## Chatswood Chase Shopping Centre

### Flood Modelling Report - Addendum

- Flood modelling report (Revision F) was issued as part of a DA submission to council for development of Chatswood Chase Shopping Centre. Council ref: DA-2022/305 ePlanning Portal ref: PAN-257802

- Council has provided a request for additional information (refer letter dated 24/01/2023) in regard to the DA with specific requests in response to the flood report.

Level 00 General Arrangement Key Plan  
Scale 1 : 500

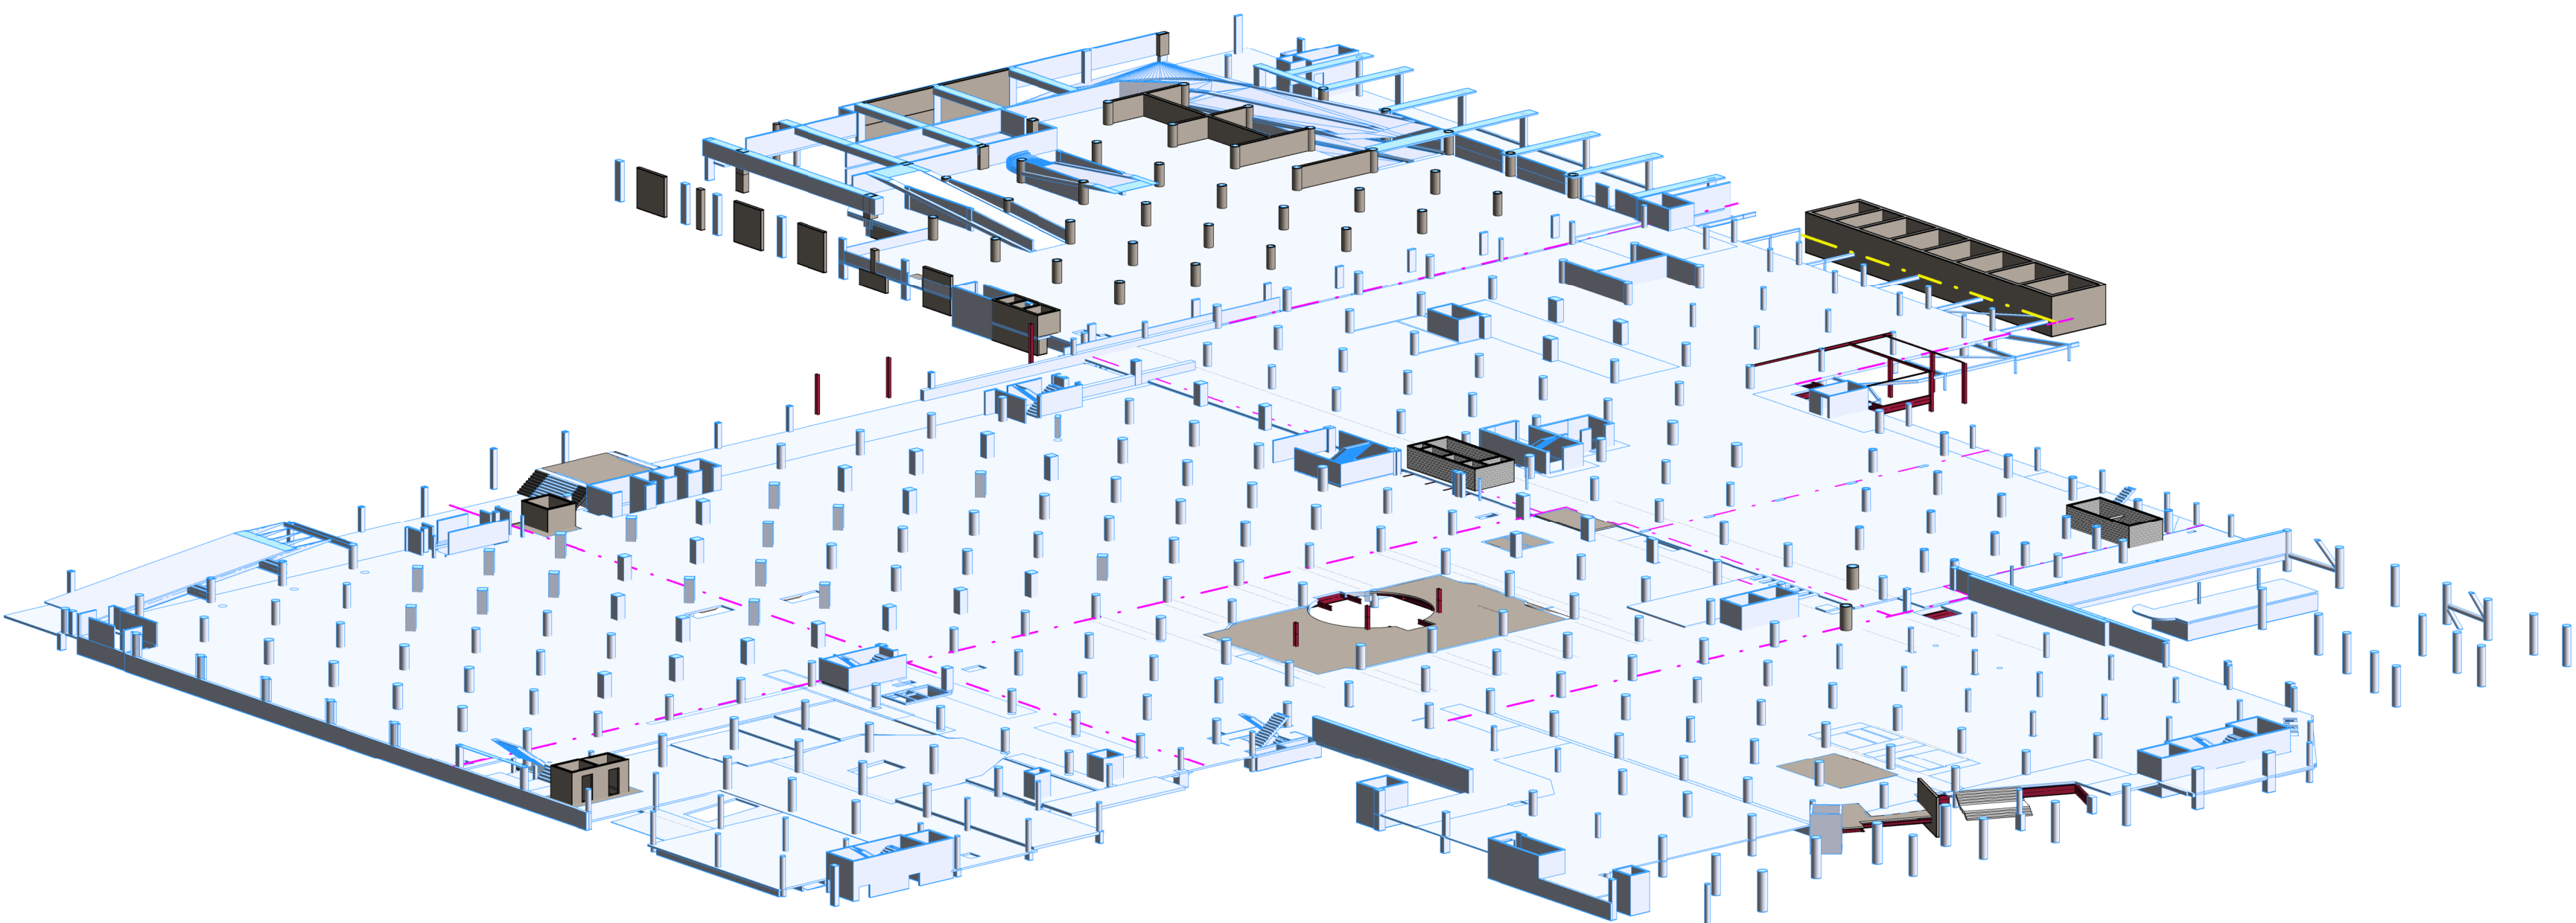
*Item 12k - Details of how the overland flow will be conveyed along the boundary of 345 Victoria Avenue and Havilah Street properties.*

Currently, excess overland flow from the low point on Victoria Avenue, not catered for in the council drainage system, flows into the Chatswood Chase Shopping Centre (CCSC) basement carpark. There is also a portion of the flow following an overland flow path, which takes water down the CCSC loading dock entry ramp, which is bounded by a parapet wall on one side and an embankment and fence at the rear of the Havilah Street properties. In some higher flow events a portion of overland flow passes through to Havilah Street via a carpark at the rear of properties on the corner of Victoria Avenue and Havilah Street. The majority of the flow then continues into the loading dock itself where some flow enters the basement carpark via a ramp from the loading dock, and the remainder of the flow continues overland along the boundary of the shopping centre until it reaches the rear of 5-7 Havilah Street where it predominantly flows through the rear of the carpark below the building and out onto Havilah Street. There is also a minor flow path (approximately 1.5m in width) around the perimeter of this building which also allows flow out onto Havilah Street. This is the existing condition.

In the proposed design, automatic flood gates will control the entry of water into the CCSC basement carpark, using a flood level control switch located in the basement which automatically triggers the gates when the water level is approximately 200mm in depth. This prevents water from entering the CCSC basement carpark greatly reducing hazard levels and risks, and the majority of excess stormwater will be diverted down the loading dock entry

ramp. A one-meter wall is proposed on the boundary to prevent minor flows through the carpark at the rear of the properties on the corner of Victoria Avenue and Havilah Street and manual flood gates are proposed to prevent flow from entering the loading dock (and thus preventing flow to the basement via this route). This contains the overland flow path to the boundary of the shopping centre bounded by the external shopping centre wall and the walls of the buildings on Havilah St. Although in high flow events, a portion of overland flow does pass through to Havilah Street via the carpark upstream of 1-3 Havilah Street, overtopping the proposed 1m wall. Again, the remaining flow will enter the rear of the 5-7 Havilah Street carpark below the building where we have proposed an updated garage door / gate with 1m solid panel at base or equivalent on the carpark entry. The purpose of the 1m panel is to retard the flow onto Havilah Street and provide a level of temporary storage to prevent unacceptable afflux downstream of Havilah St in the residential area. Water from the 5-7 carpark can drain to Havilah Street via the minor overland flow path around the perimeter of the building. Flow can also exit the carpark directly to the minor overland flow path via large openings along the NW side of the carpark. In high flow events water will overtop the 1m flood barrier in the carpark entry at 5-7 Havilah Street and exit the carpark into Havilah Street.

It should be noted that the property at 5-7 Havilah Street is owned by Vicinity and the risks to life and property due to increased flood levels are far less than the risks associated with the alternative, which is to allow the CCSC carpark to flood. The risks within this smaller carpark will be managed as part of the flood management plan which will include removal of all vehicles and deployment of the 1m flood barrier / garage door (refer attached plan – MAKE Drawing AR-MAK-DRG-DA1200) when the other manual flood barriers are triggered within the centre.

Refer to attached photos of overland flow path.
